s72 Amendment Officer Report

309 - 325 Bourke Street,
Melbourne

Section 72 Amendment Officer Assessment Report
Development Approvals & Design

Department
of Transport
and Planning

Proposed signage – Bourke Street elevation and floor plan (LED screens shown in green)

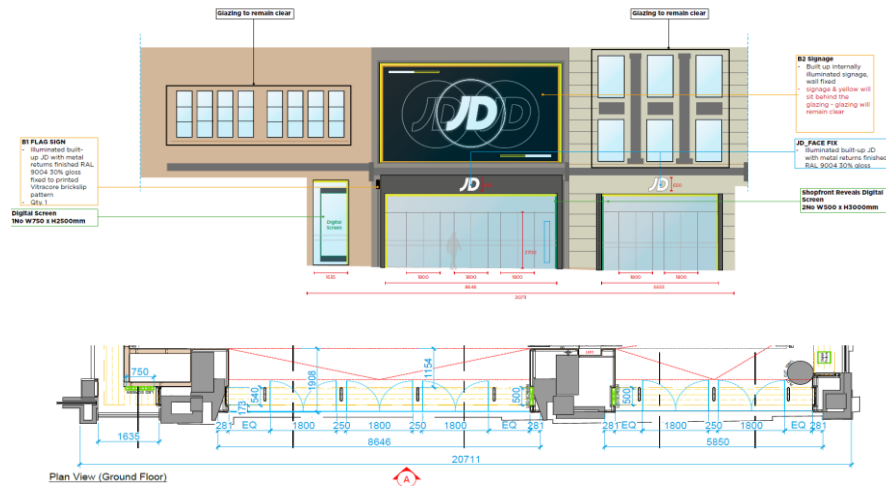
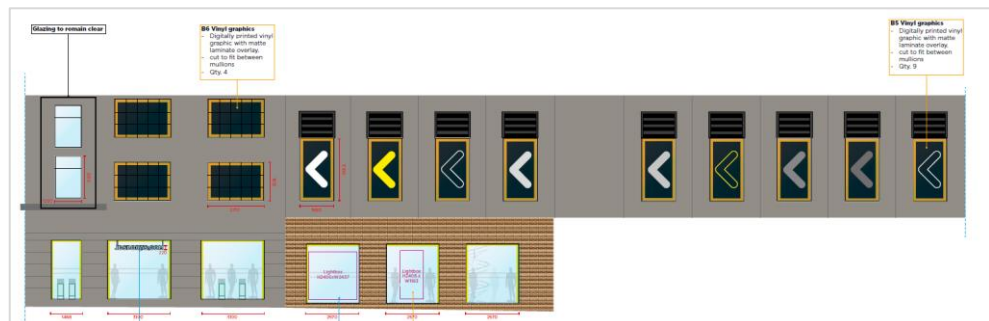
The LED screens proposed at the entrances of the store on Bourke Street will not be orientated outward to the street, however, will be visible to pedestrians travelling east or west along the southern side of the mall. While these screens will be noticeable to pedestrians in the immediate vicinity, the screens will be largely obscured from view for pedestrians further from the store frontage, particularly on the northern side of Bourke Street. Given the screens are contained within the tenancy and are not orientated directly to the street frontage, they are considered acceptable.

The use of illuminated yellow lightboxes is part of the JD Sports store branding, consistent across all retail stores. The extent of the lightboxes is limited to ground floor windows and entrances and the large first floor infill window. The lightbox will be visible external to the store, however, are partially recessed within the building

Endorsed plans – Ground floor tenancies

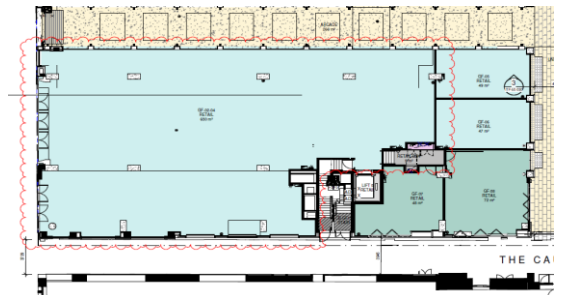
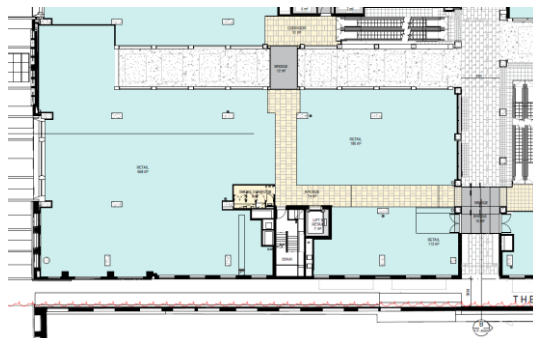
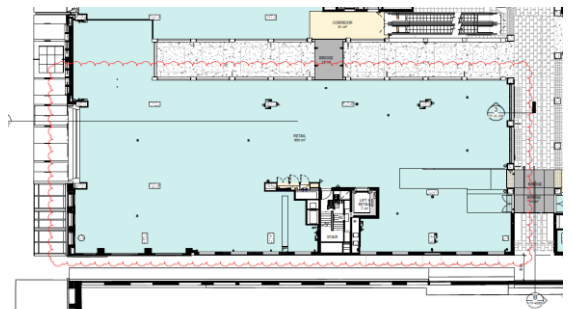
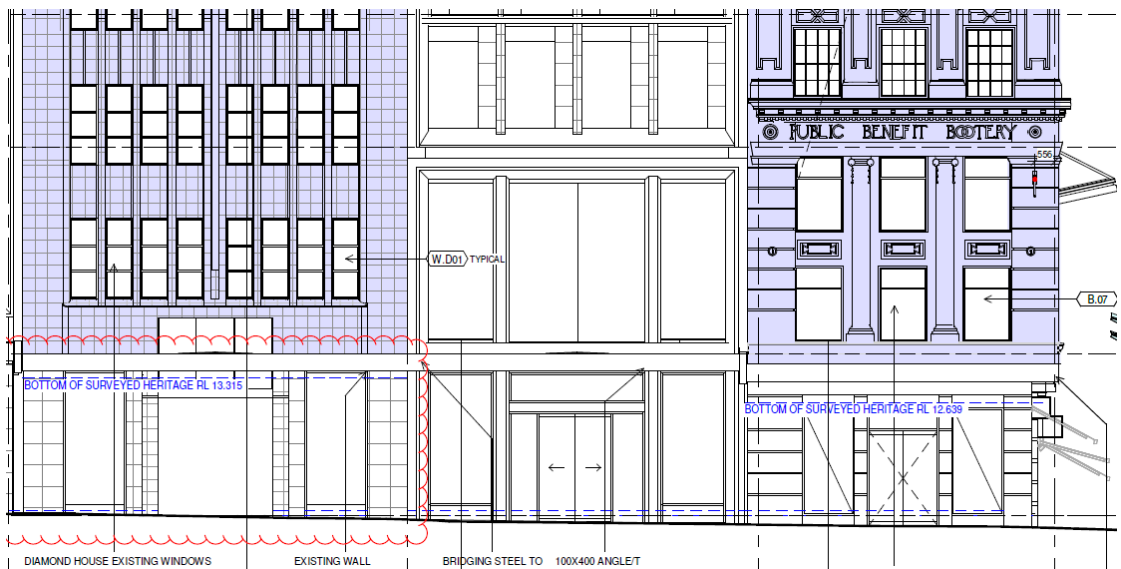
The proposed amalgamation of ground floor and first floor tenancies at the northwest of the development is considered a generally minor change. The configuration of the approved tenancies was designed prior to securing prospective retail tenants and some degree of internal alteration to accommodate specific needs of tenants is reasonable. This change is sought to facilitate the requirements of JD Sports who require a large floor area to deliver a store across two floors of the development.

This change is internal only and will not result in any significant impacts to the external façade of the development. This change is recommended to be supported.

Endorsed northern elevation – Bourke Street facade

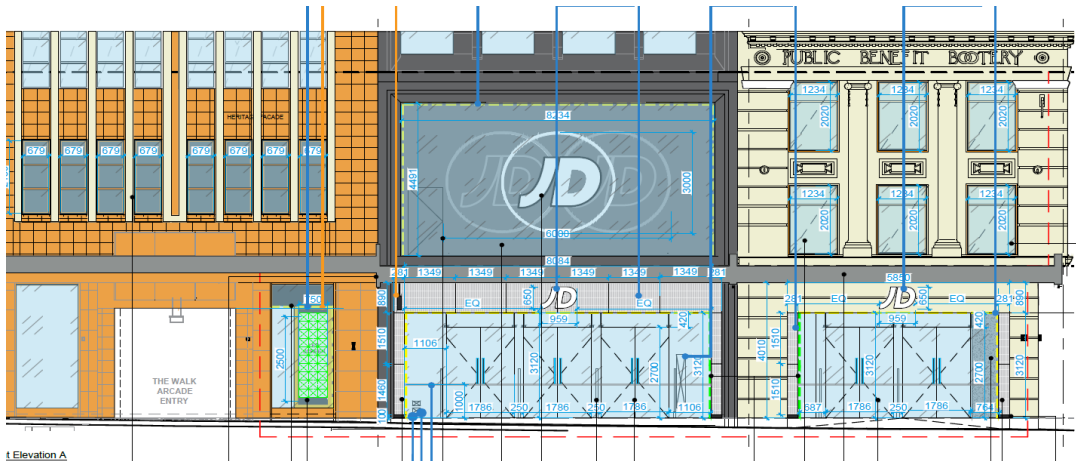
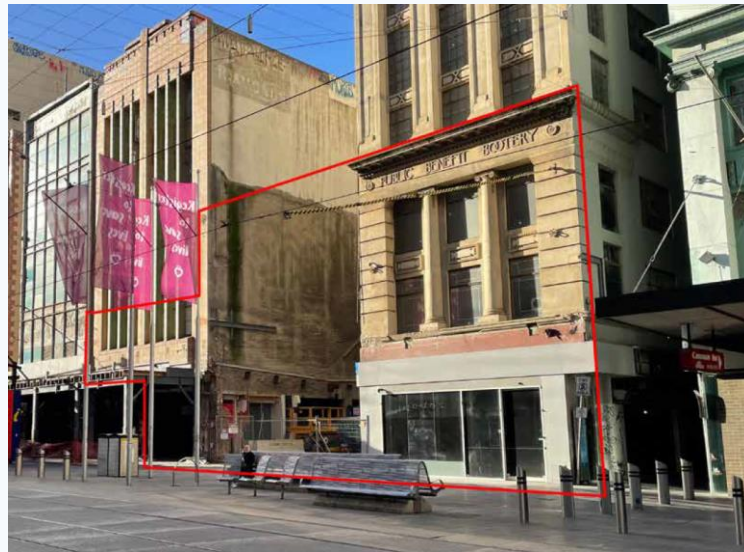
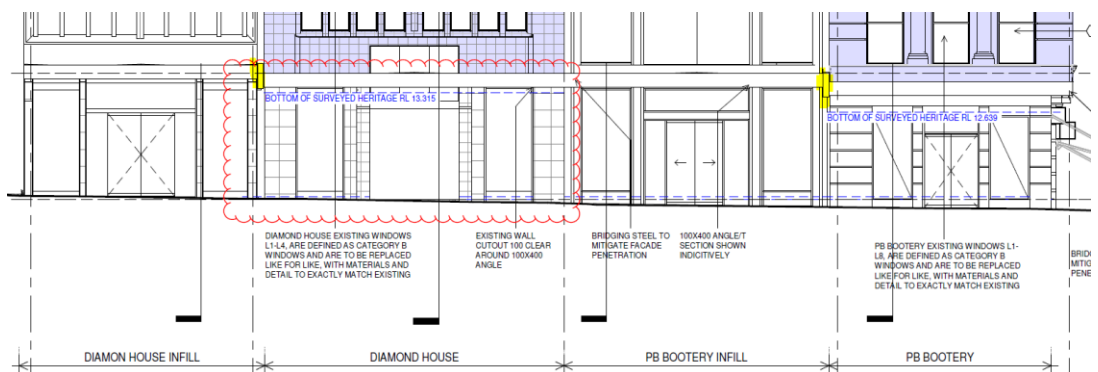
The removal of approved masonry columns at the ground floor of the Bootery Building is not preferred, however this outcome is considered acceptable given the ground floor of this building had been significantly modified prior to this development commencing (refer to image below of subject site prior to development). As such, the approved columns were designed to replicate the original design and did not constitute original heritage fabric. There is a

significant extent of heritage fabric which is being retained and has been restored as part of this development and this change does not undermine the overall benefits to the heritage streetscape.

The increased extent of glazing on the ground floor infill and Bootery buildings is acceptable, noting the amended design will provide increased for visual permeability into the store and is generally consistent with surrounding retail frontages in the Bourke Street Mall.

The proposed amended material to the infill building is acceptable given the similarity of the material. The approved material is charcoal coloured aluminium cladding, while matte black aluminium cladding with a crushed grid print in now proposed. These materials are considered to read very similarly and do not constitute a significant change. This material is also proposed in two narrow stripes alongside the entrance to the tenancy from Bourke Street at the PB Bootery Building. The use of the material is minor, measuring 281mm on either side and is not anticipated to visually dominate the façade. This colour is consistent with JD Sports branding is an acceptable outcome.

The combination of three windows on the first floor of the infill building to create large window is recommended to be supported. While the window design previously approved was more response to the façade pattern of the adjoining buildings, the amended window configuration will still ensure the buildings appear as distinct facades and is acceptable.

Endorsed northern elevation – Bourke Street canopy

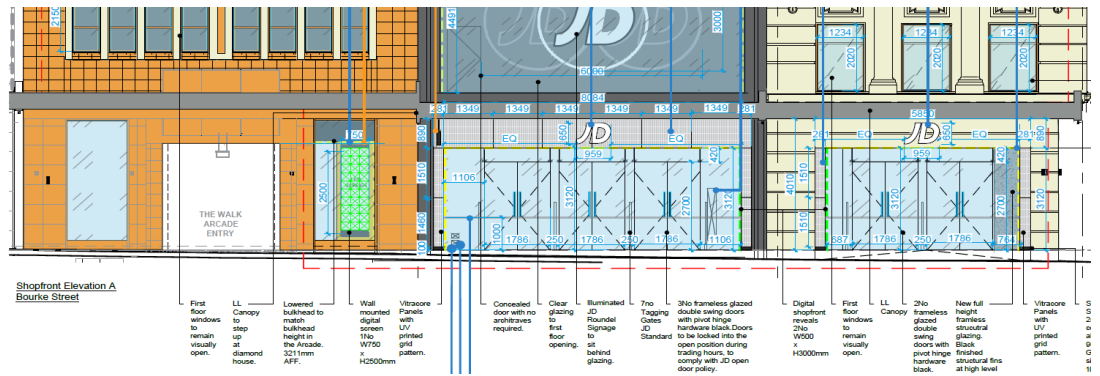
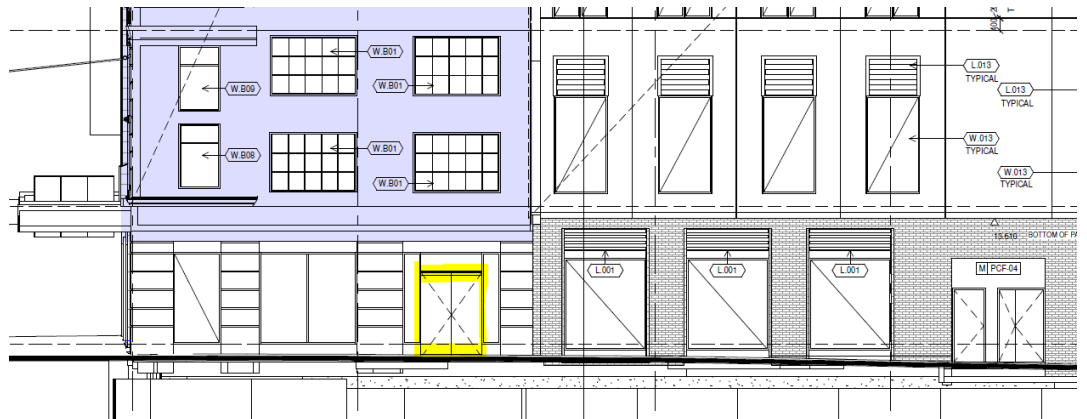
The amendment to the Bourke Street canopy is minor. While the step approved at the western end of the canopy at the intersection of the Infill and PB Bootery buildings has been deleted, an additional step has been added in the central section between the Infill and Diamond House buildings. The steps in the canopy ensure the façades visually read as separate buildings. The variation in materiality and designs in façades as constructed is considered to ensure this objective is achieved, despite the minor change to the canopy design. This change is therefore considered recommended for approval.
